Addendum No. 1

RE: Contract # C205036

Robeson County (U-5797)

SR-1997 (FAYETTEVILLE RD) FROM FARRINGDOM ST TO EAST 22ND ST

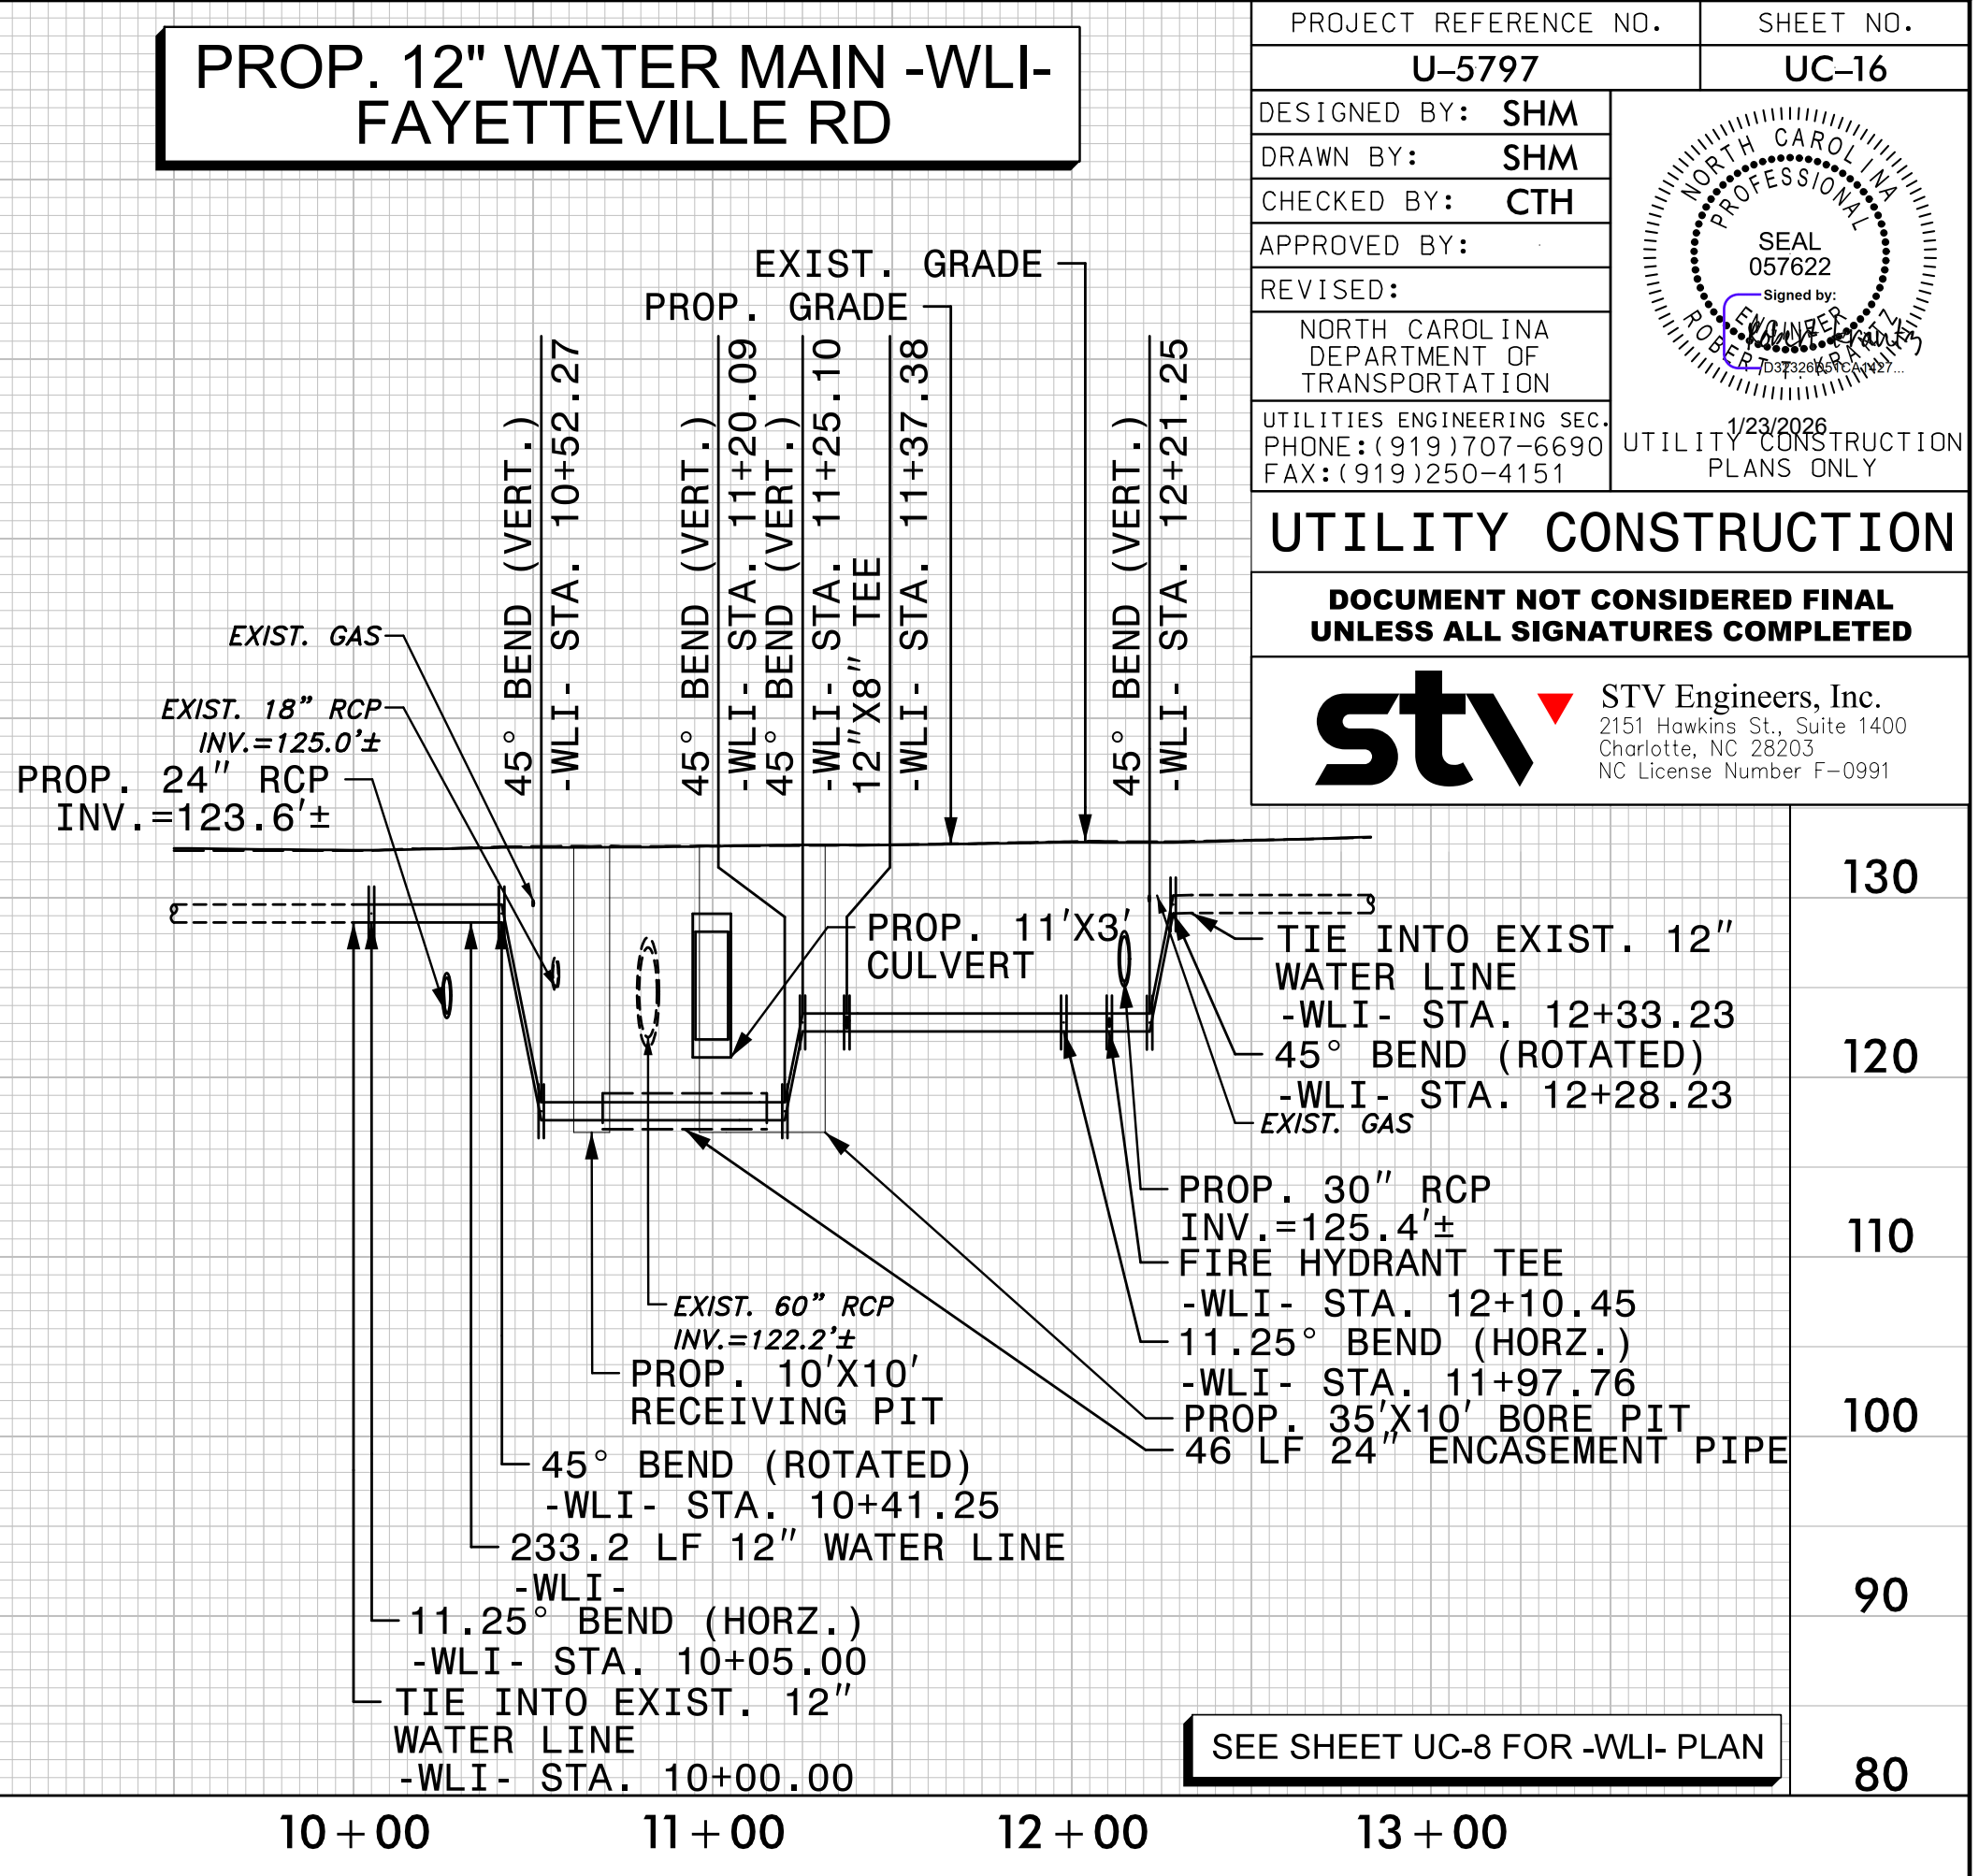
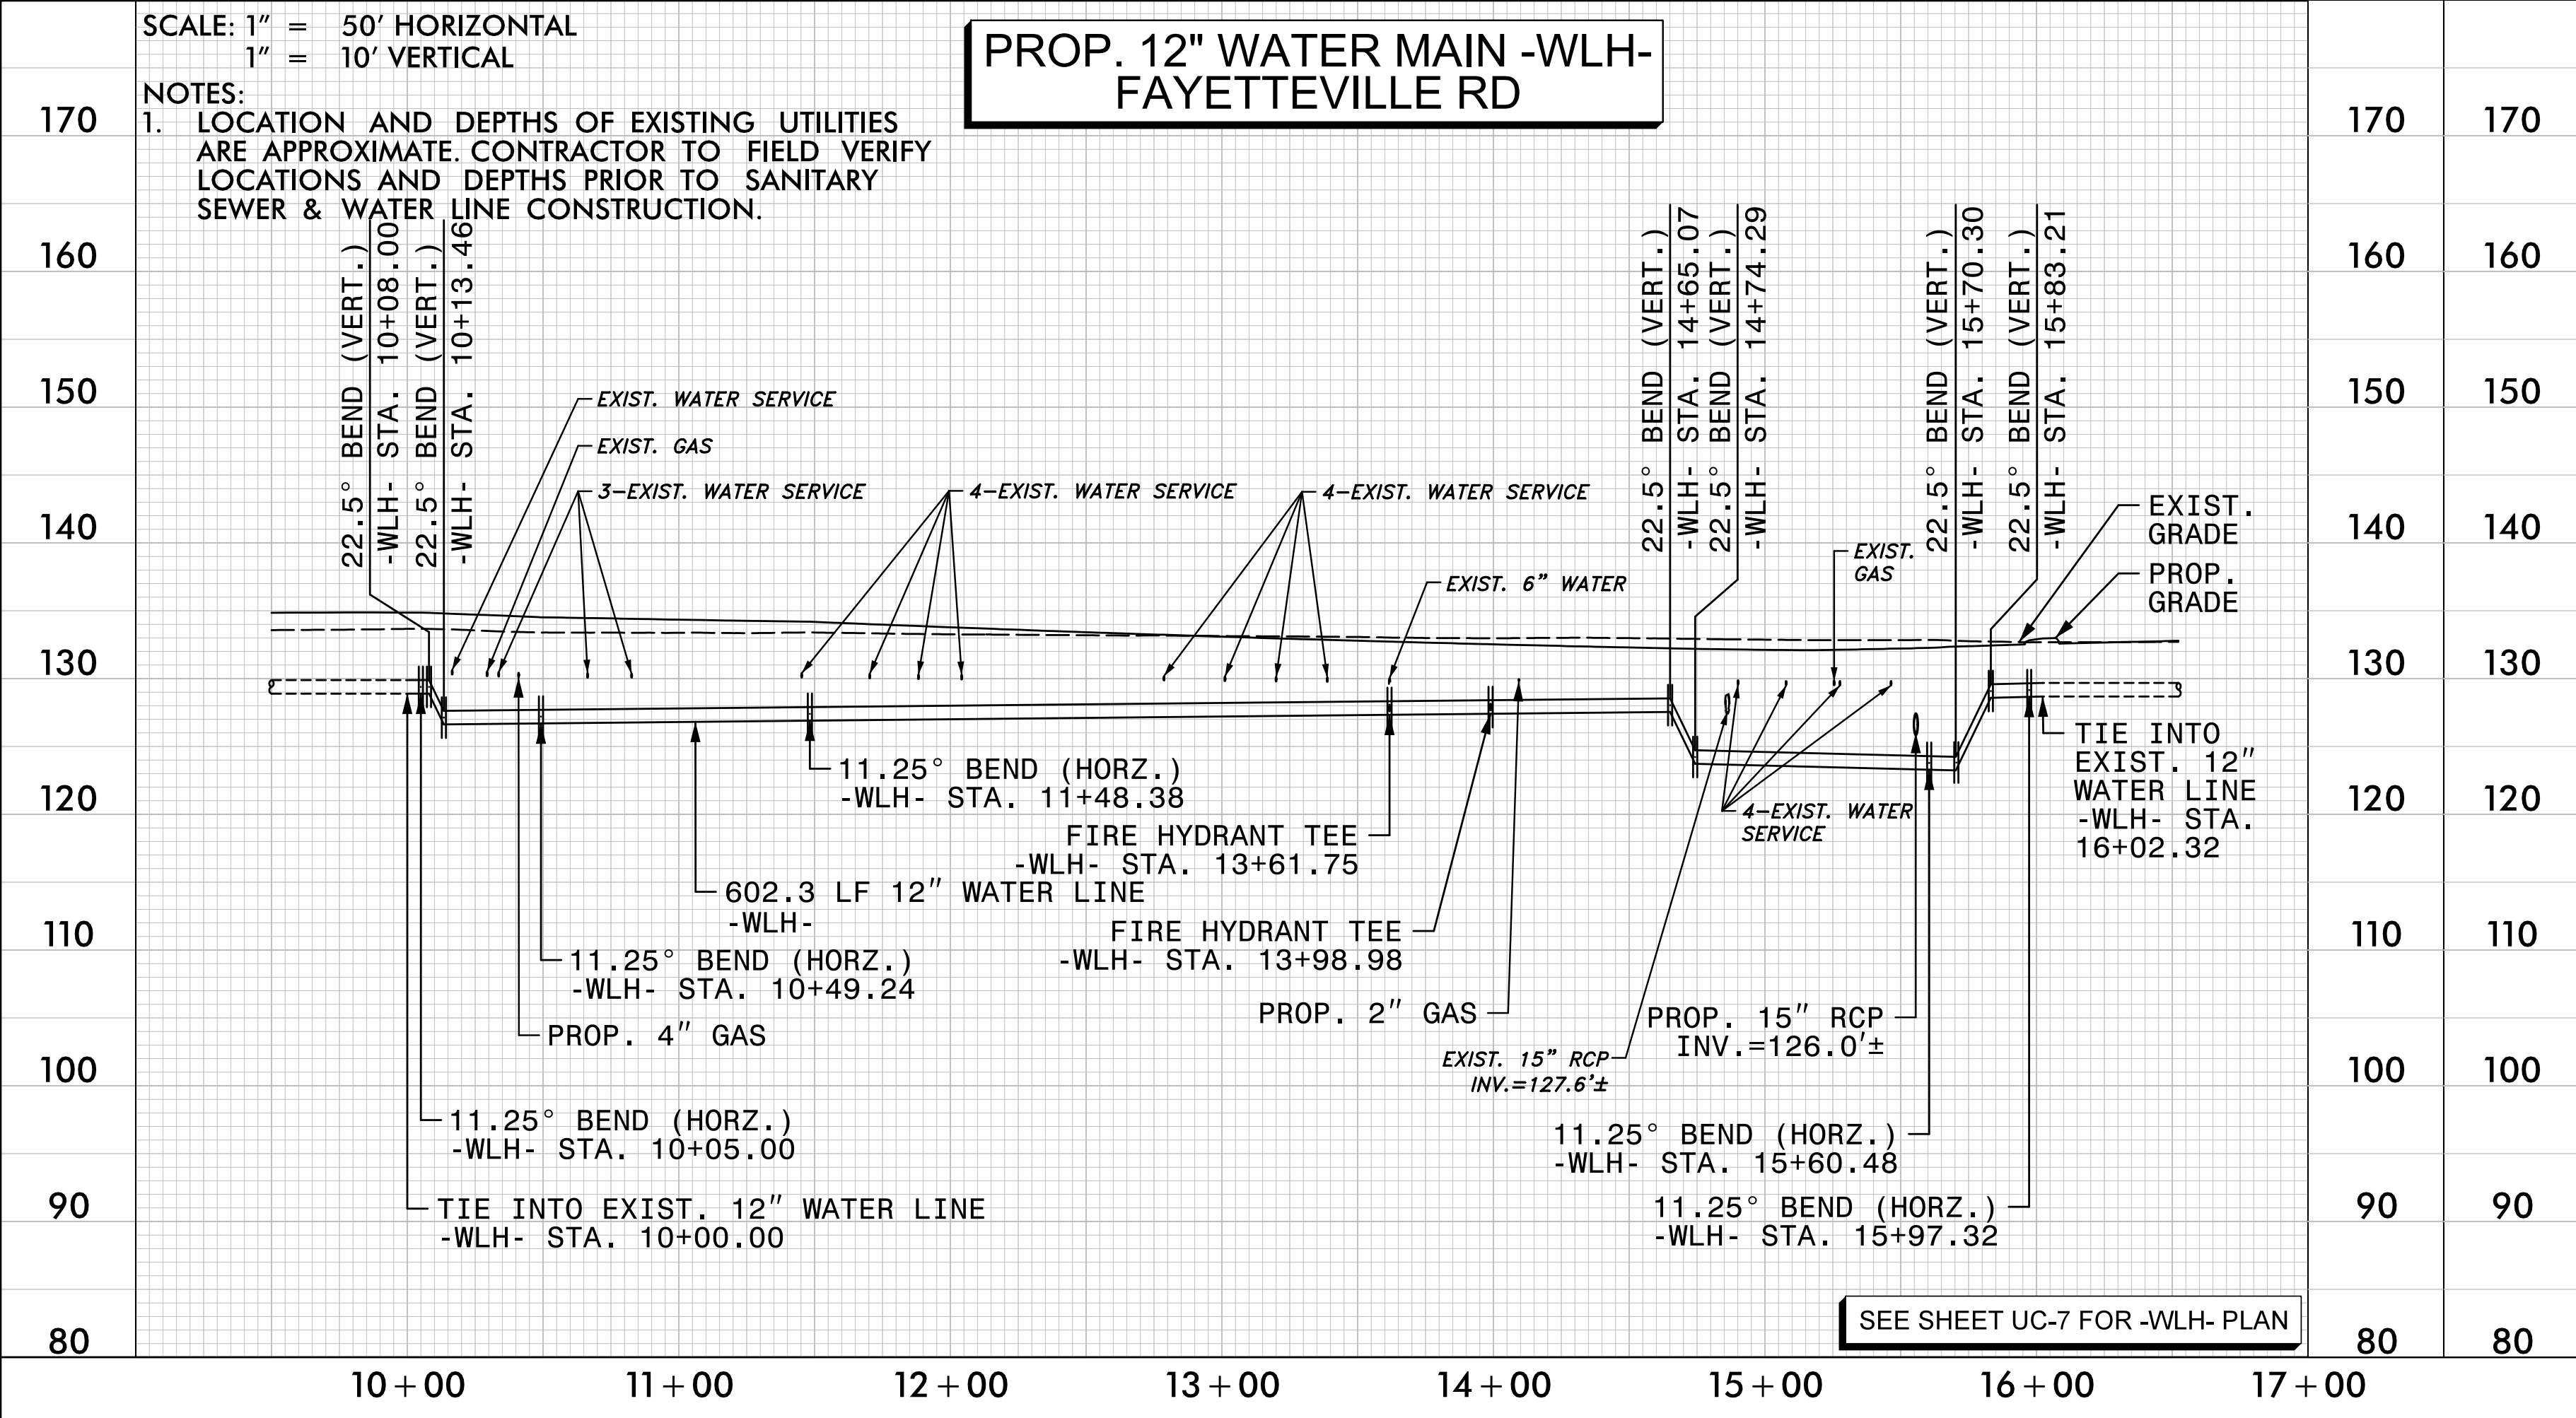
Sheet No.	Revision
UC-11	- Removed the design of waterline K around 97ft of 12in WL - Removed pipe DI water pipe fittings (2 - 450 bends, 1- 22.50 bend and 2 – 11.250 bends) - Removed 2 -12inch insertion valves - Removed 1- reconnect water meter - Removed a 97ft of 12in utility pipe that was meant to be abandoned
UC-16	Removed profile of waterline K (referenced out)
